COUNCIL ASSESSMENT REPORT

Panel Reference	PAN-202308
DA Number	RA22/1002
LGA	Shoalhaven City Council
Proposed Development	Residential Flat Building (Affordable Rental Housing)
Street Address	44-52 Coomea Street, Bomaderry
Applicant/Owner	Southern Cross Community Housing Ltd
Date of DA lodgement	24 March 2022
Total number of Submissions Number of Unique Objections	None
Recommendation	Approval
Regional Development Criteria (Schedule 6 of the SEPP (Planning Systems) 2021)	<p>3 Council related development over \$5 million</p> <p>Development that has a capital investment value of more than \$5 million if—</p> <ul style="list-style-type: none"> a) a council for the area in which the development is to be carried out is the applicant for development consent, or b) the council is the owner of any land on which the development is to be carried out, or c) the development is to be carried out by the council, or d) the council is a party to any agreement or arrangement relating to the development (other than any agreement or arrangement entered into under the Act or for the purposes of the payment of contributions by a person other than the council). <p>5 Private infrastructure and community f

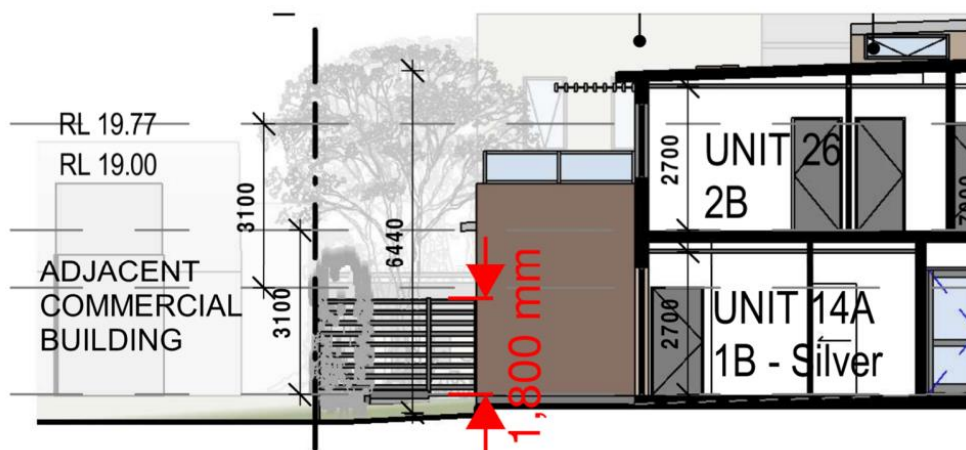
The proposal complies with the above design criteria setbacks to the northern and southern boundaries of the site. The proposal however involves encroachments to the minimum separation distances to the following apartments:

- Building A
 - Ground Floor – Unit 13A, 16A – living spaces setback >6m from eastern boundary
 - First Floor – Unit 26A – balcony setback >6m from the eastern boundary
- Building B
 - Ground Floor – Unit 3B – bedroom windows >6m separation distance from eastern boundary
 - First Floor – Unit 9B – balcony setback >6m from eastern boundary
 - First Floor – Unit 8B – bedrooms <6m from eastern boundary

The proponent has provided justification in relation to the encroachments identified above within pages 56-59 of the Statement of Environmental Effects (March 2022) and Response to additional information date 20/05/2022. A summary of the response provided by the proponent is provided below for each apartment identified:

- *We note ground floor units noted above are provided with screening to sides POS and the boundary to a height of 1.8m as outlined on the below screenshot. In addition, screen planting is provided.*
- *Boundary fencing along the eastern boundary that will prevent direct views from these rooms to properties to the east.*
- *Windows to the two bedrooms located in Unit 3B have been orientated away from the eastern boundary*
- *Building to the east of these units are down hill which will reduce privacy concerns into the property*

Assessment Comment: With consideration to the above, the non-compliant separation distances for Unit 13A, 16A and 3B is considered to provide reasonable levels of external and internal visual privacy and no adverse overlooking to neighbouring properties.

Unit 26A

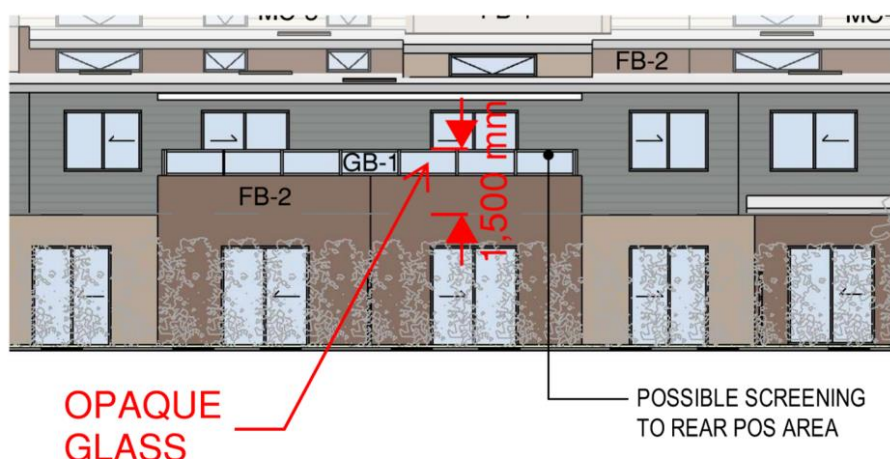
- Unit 26A POS area is provided with a solid balustrade to 1m and then 500mm of opaque glass above, providing screening to a total height of 1500mm as depicted below.
- This is considered suitable screening for this unit and protecting any potential overlooking into the adjoining properties

- screening in this instance has been amended to a louvre screen to allow outlook directly through the screen and upward, but prevent overlooking in a downwards direction to the POS below and neighbouring site. Refer image below. This would be utilised to screening that is higher than 1200mm and will be finished to match the batten style screening proposed between POS areas on the site. Refer attached revised drawings.

Assessment Comment: The solid and louvre screening will restrict overlooking to the neighbouring property and maintain internal and external privacy for the unit.

Unit 8B

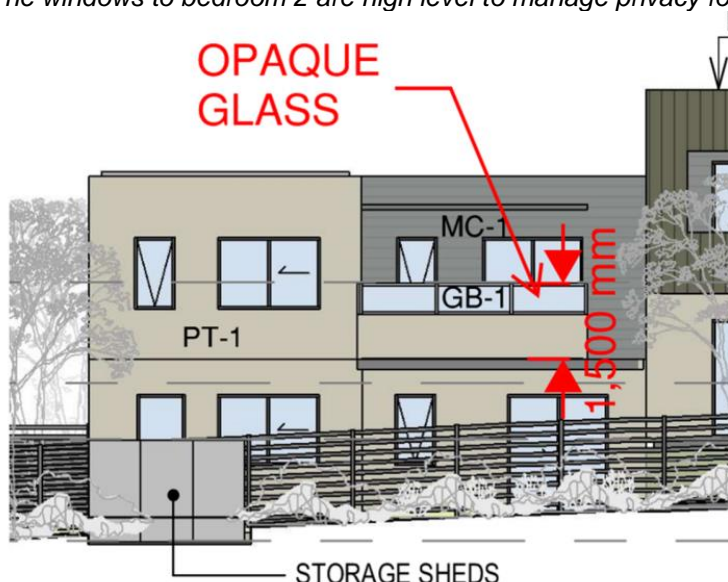
- Units 8B POS area is provided with a solid balustrade to 1m and then 500mm of opaque glass above, providing screening to a total height of 1500mm as depicted below.
- This is considered suitable screening for this unit as well as any potential overlooking into the communal open space.
- In addition, the windows to bedroom 1 have a sill height of 1.2m and is suitably separated from the COS area to avoid privacy issues that would be managed through blinds and curtains.
- The windows to bedroom 2 are high level to manage privacy for this room

- screening in this instance has been amended to a louvre screen to allow outlook directly through the screen and upward, but prevent overlooking in a downwards direction to the POS below and neighbouring site. Refer image below. This would be utilised to screening that is higher than 1200mm and will be finished to match the batten style screening proposed between POS areas on the site. Refer attached revised drawings.

Assessment Comment: The solid and opaque screening will maintain internal and external privacy for the unit.

Unit 9B

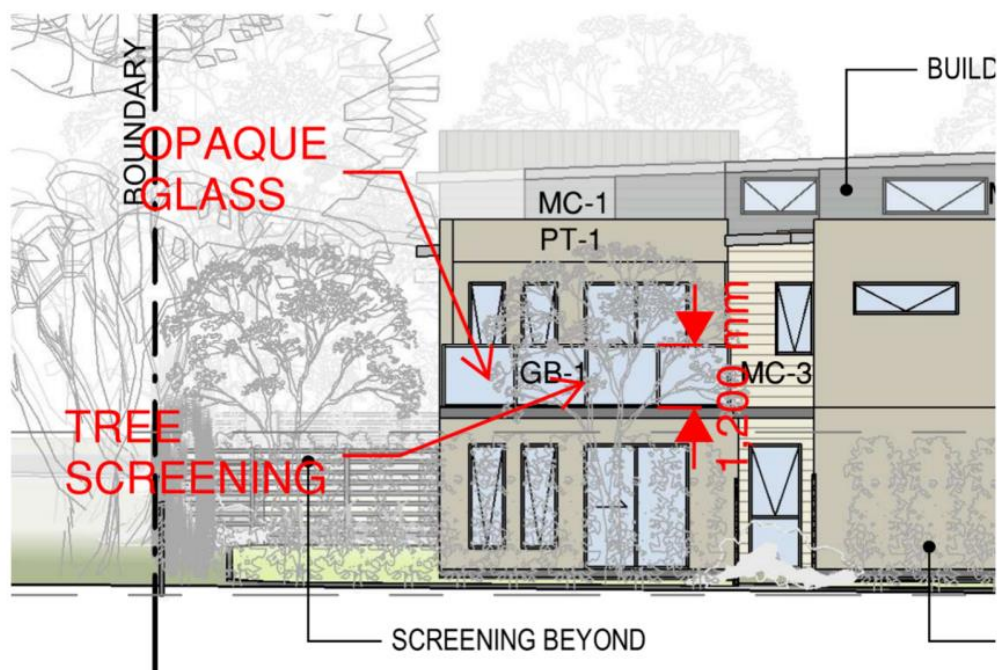
- Units 9B POS area is provided with a solid opaque glass balustrade to a height of 1.2m.
- This space is setback further from the boundary than other POS areas noted above, with the windows to the habitable room of Unit 9B further back (greater than 6m from the boundary).
- A feature trees is also proposed here to add to the privacy control of this area.

Assessment Comment: The proposed screening and tree planting will restrict overlooking to the neighbouring property and maintain internal and external privacy for the unit.
